BEFORE THE PUBLIC SERVICE COMMISSION
OF THE STATE OF MISSOURI

In the Matter of)	
the Resource Plan of)	File No. EO-2015-0252
KCP&L Greater Missouri Operations Company)

Comments of Natural Resources Defense Council

Figure 2 | PG&E Commercial HVAC Program Results: 1993-2013

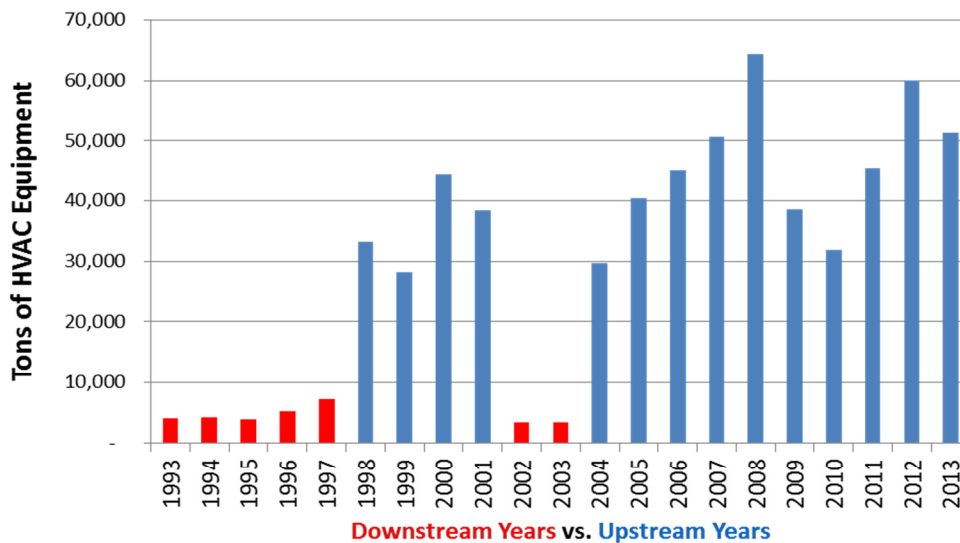
Upstream programs involve working directly with manufacturers and distributors to promote high efficiency equipment, including giving incentives to the manufacturers and distributors rather than the end users. In this way, customers do not need to do any proactive activity to participate in the program – they just see the discounted products on the store shelves or in contractor’s bids and may not even realize that they have just participated in an efficiency program. Further, since retail markups are usually based on a percentage of wholesale prices, by lowering the wholesale price of the product upstream incentives can use less program costs to achieve the same reduction in retail prices. In addition, these upstream market actors are best situated to promote high efficiency products to their customers and are necessarily involved at the appropriate time for time-dependent installations such as replacement-on-failure. Recent efforts in Massachusetts, California and New Brunswick moving standard rebates for lighting and HVAC measures completely upstream where distributors are provided an incentive based on wholesale incremental costs for each unit they sell have been very successful. For example Pacific Gas and Electric’s HVAC program’s participation increased by an order of magnitude during years when the incentives were moved upstream, as shown in the figure below²⁴.
